Diablo Canyon Units 1 and 2

Response to NRC Request for Additional Information Regarding PG&E Letter DCL-11-072, "License Amendment Request 11-06, Revision to Technical Specification 3.3.5, 'Loss of Power (LOP) Diesel Generator (DG) Start Instrumentation" dated October 24, 2011

***PG&E Response to NRC Request for Additional Information for  
Diablo Canyon Power Plant Regarding Technical Specification 3.3.5***

**Attachment 1  
PG&E Drawing 441286**

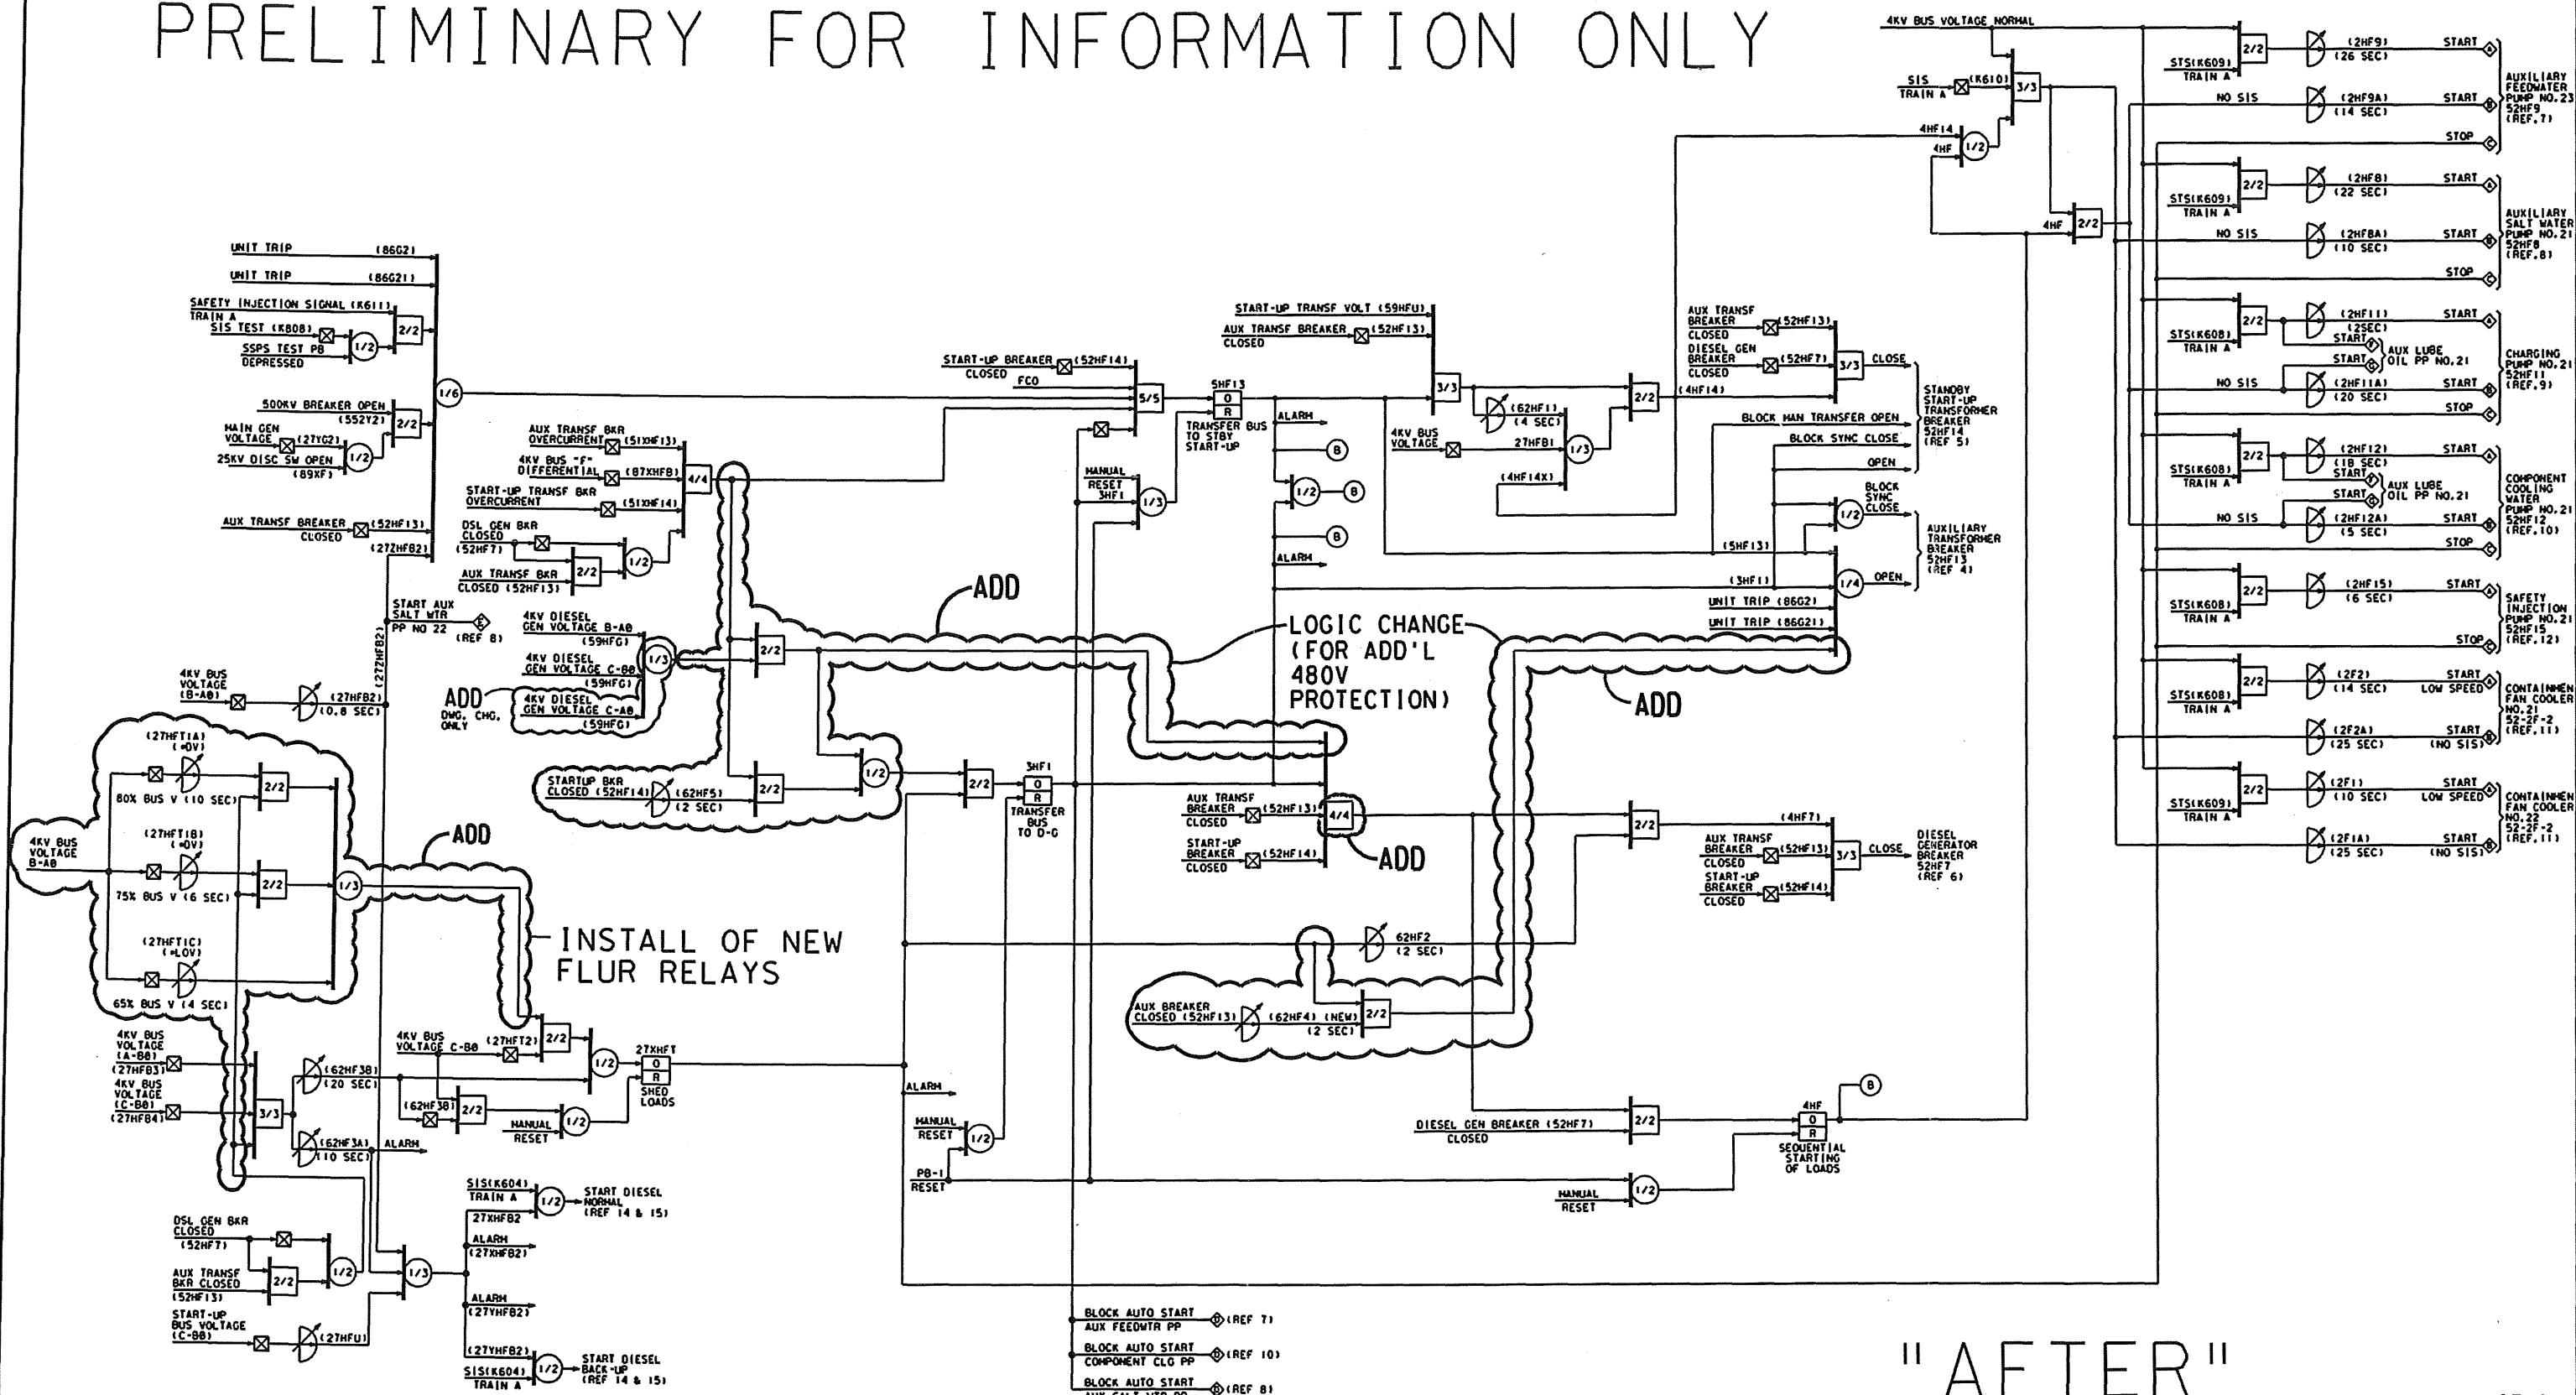
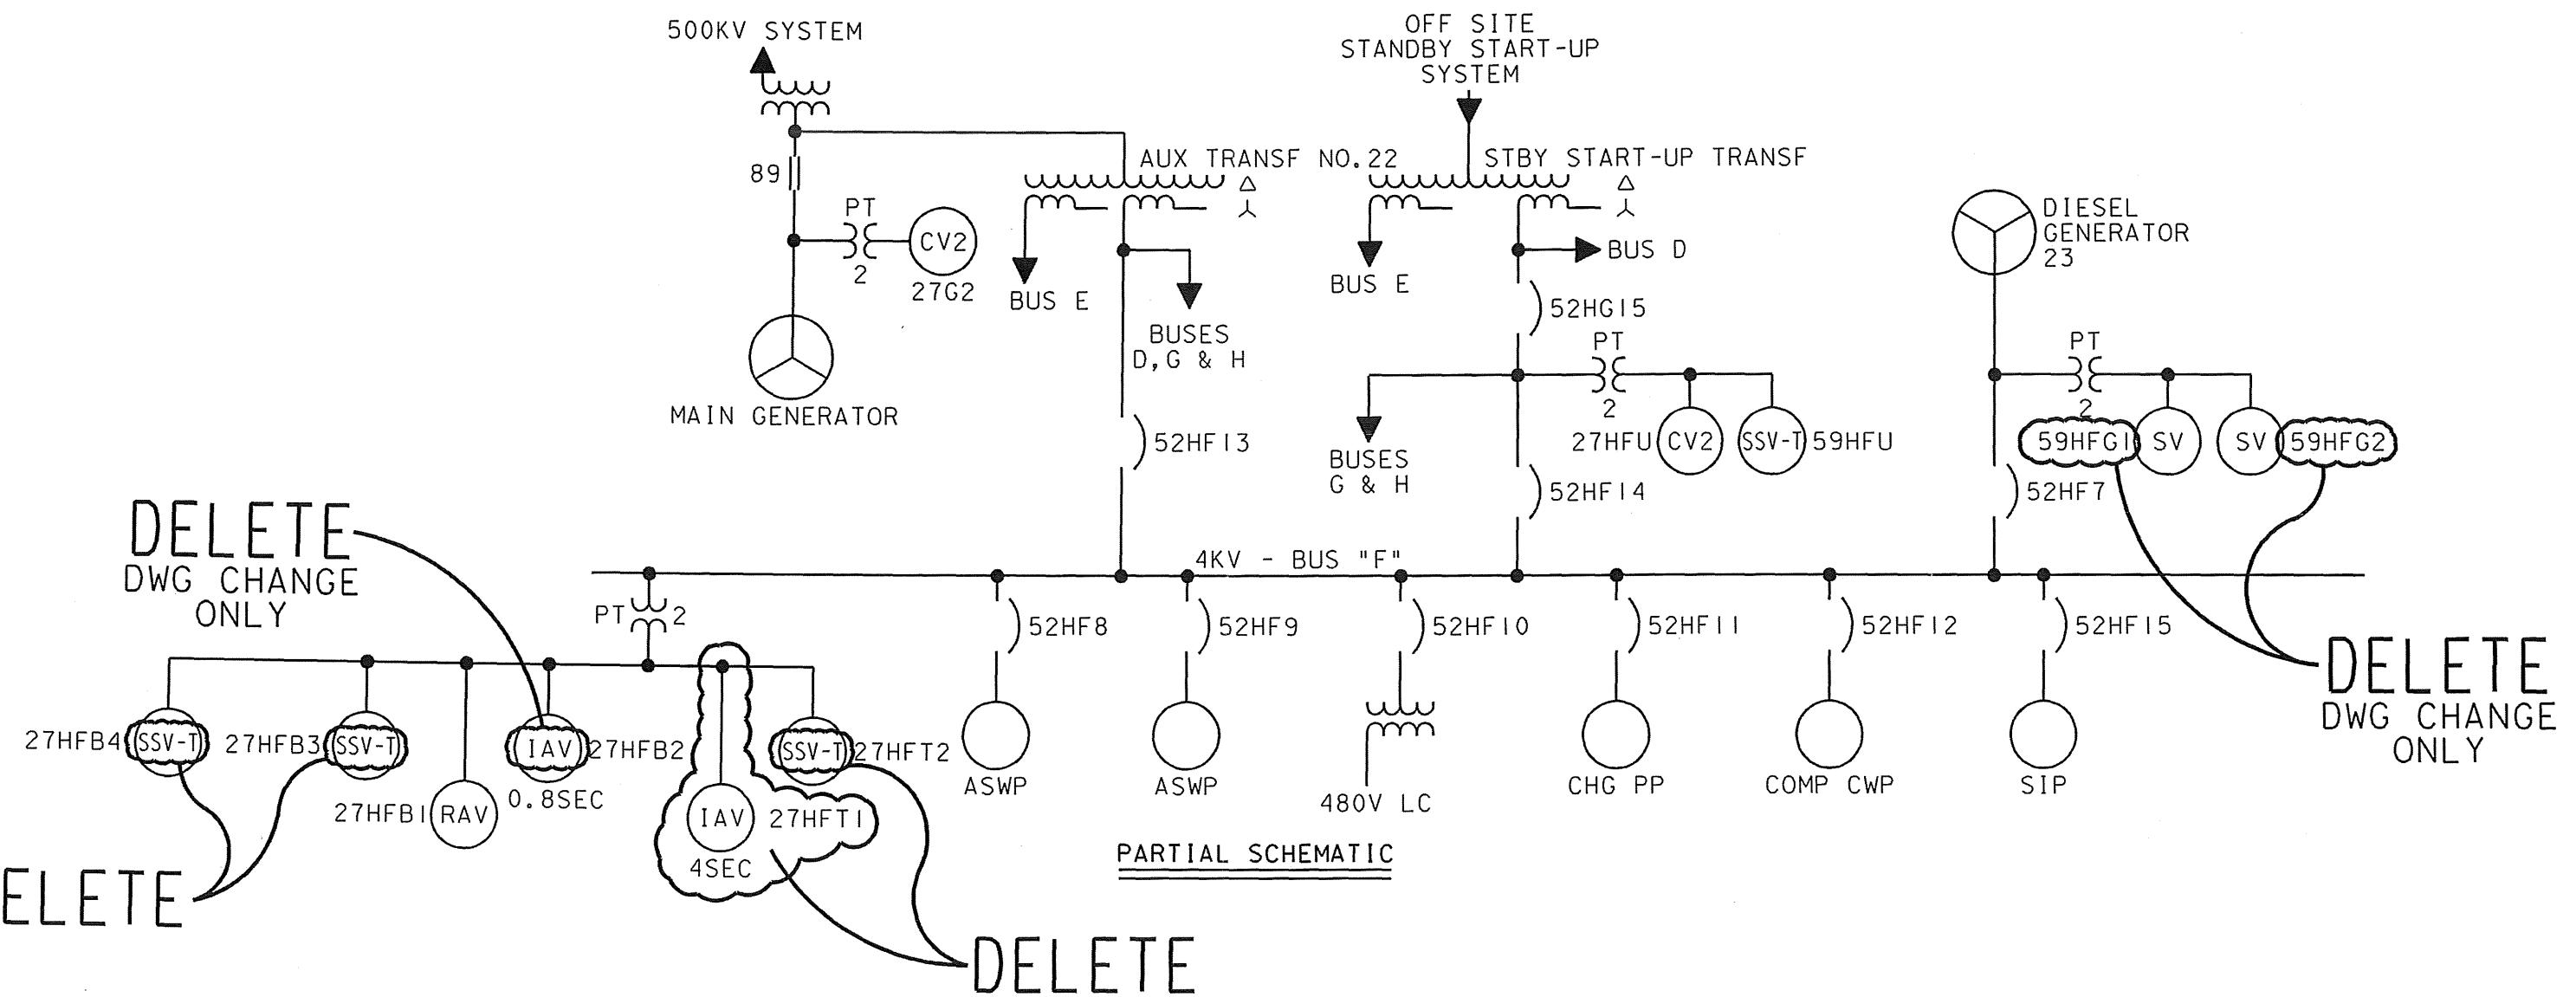
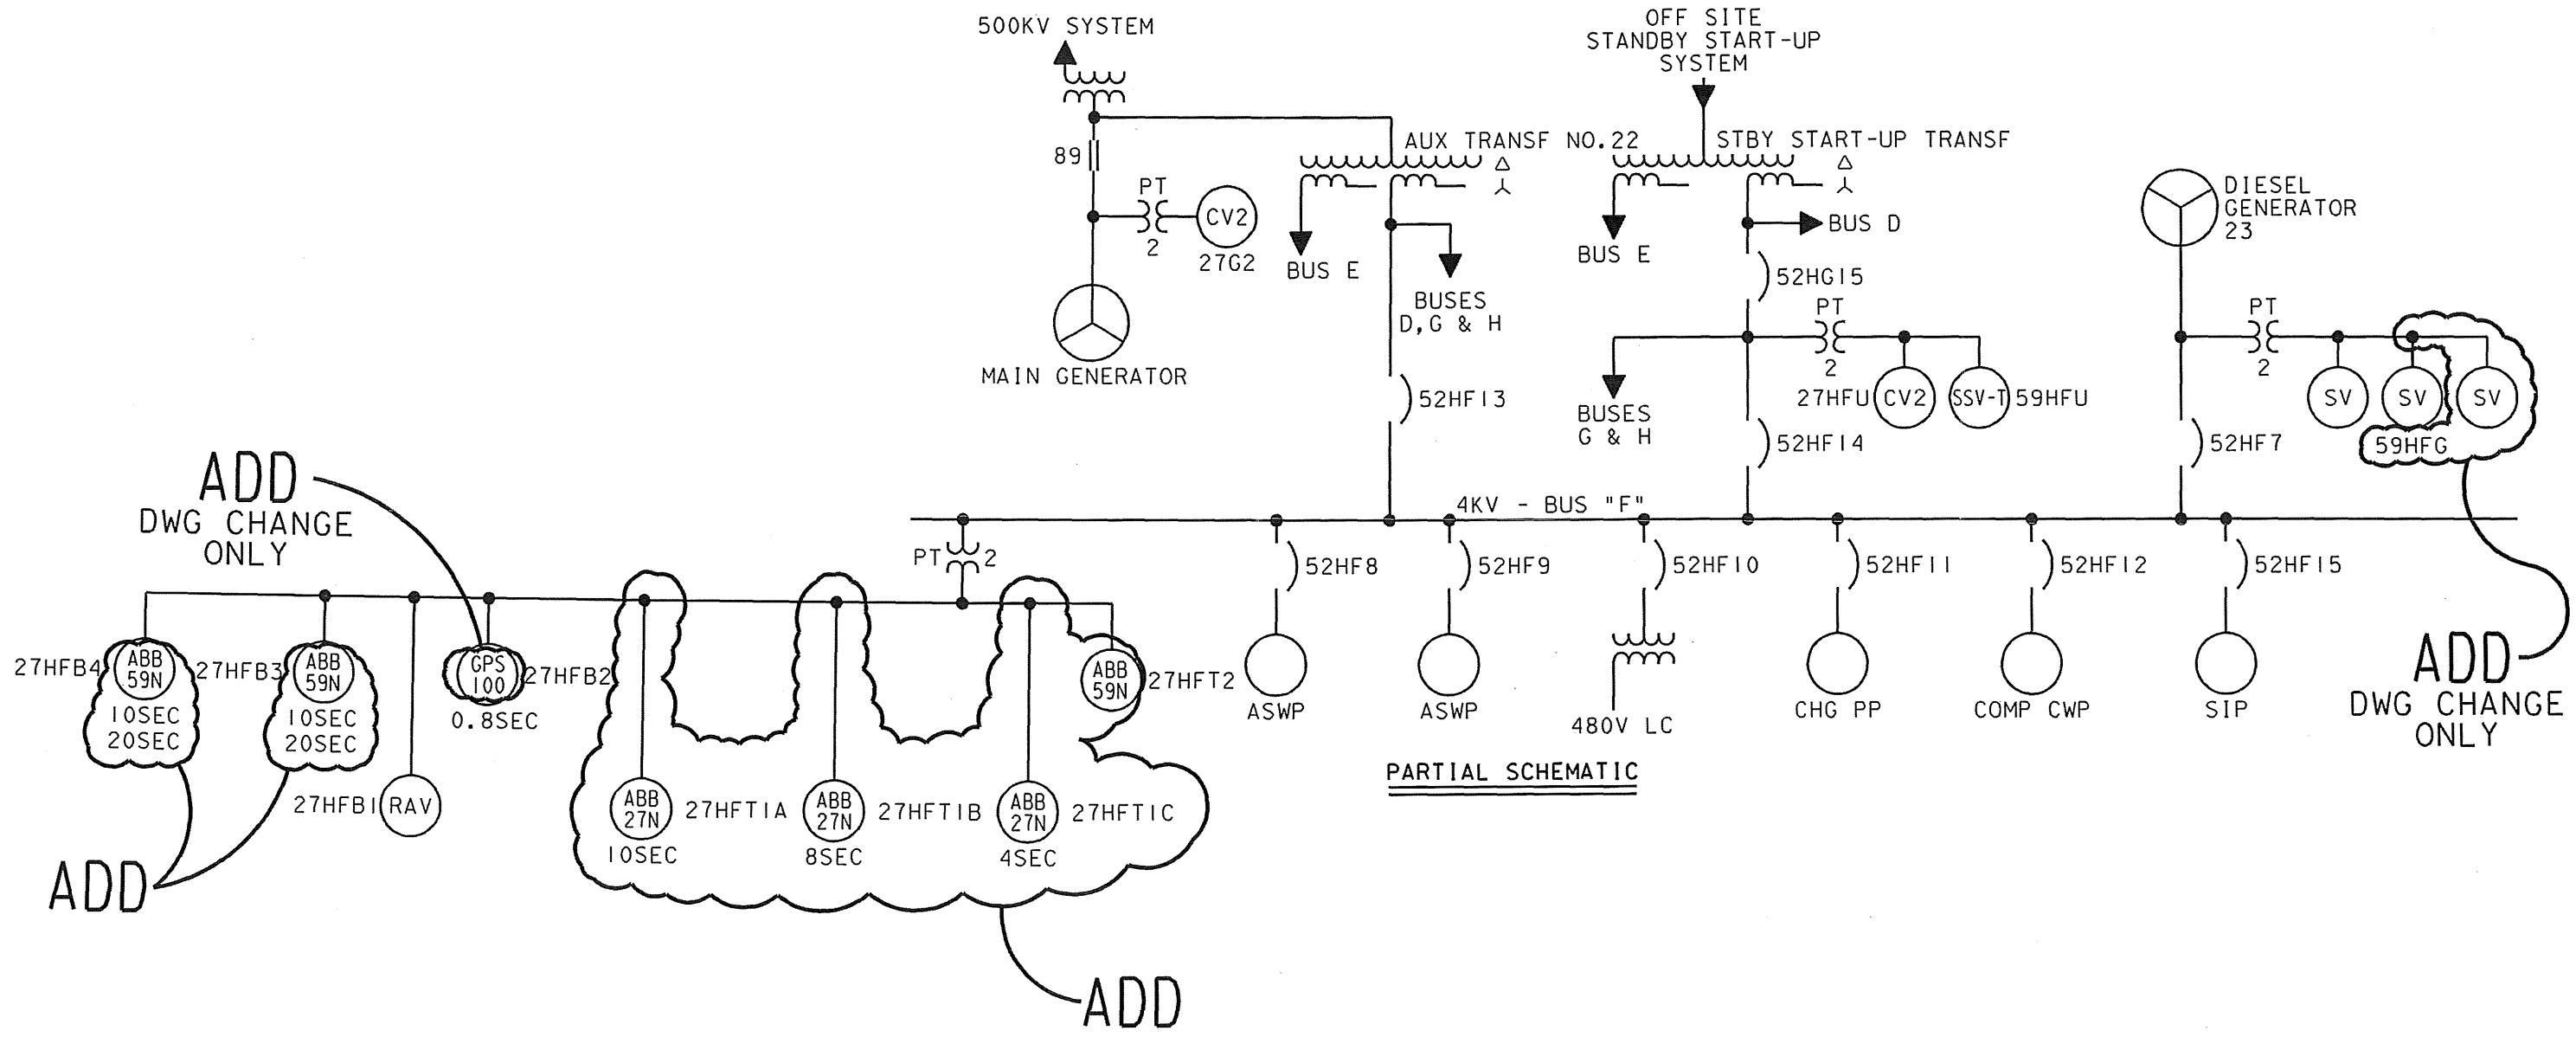
*Please provide diagrams indicating how the different devices described above are connected including the connection of the potential transformers and the relays, to enable the staff to understand the justifications requested above. Indicate what combination of relays are required to ensure that the required protective action is successfully achieved.*

Informational logic diagrams, schematics and connection diagrams are attached to this submittal as listed below. Drawings are stamped "PRELIMINARY FOR INFORMATION ONLY" as the design change to implement the new protective logic is still in the development phase. However the following is not expected to change: logic, coincidence, permissive design, and relay connection.

Reference page 2 of Attachment 1, PG&E Drawing 441286, for the following explanation of required relays for protective function. Under the new protective logic design for degraded bus voltage conditions, where bus voltage is less than 80 percent of nominal, the protective load shed function is initiated by the First Level Undervoltage Relays. A combination of either of the three 27HxT1y relays (where x designates the bus "F," "G," or "H" and y designates the degraded voltage level "A," "B," or "C") and the 27HxT2 instantaneous relay are required for initiating the load shed protective function for the respective bus. At degraded voltages between 80 percent of nominal and 91 percent of nominal, the protective load shed function is initiated by the Second Level Undervoltage Relays and remains unchanged from previous design. A two out of two coincident pick-up of the 27HxB3 and 27HxB4 Relays in combination with a timeout of the 62Hx3B Timer Relay is required for initiating the load shed protective function for each bus.
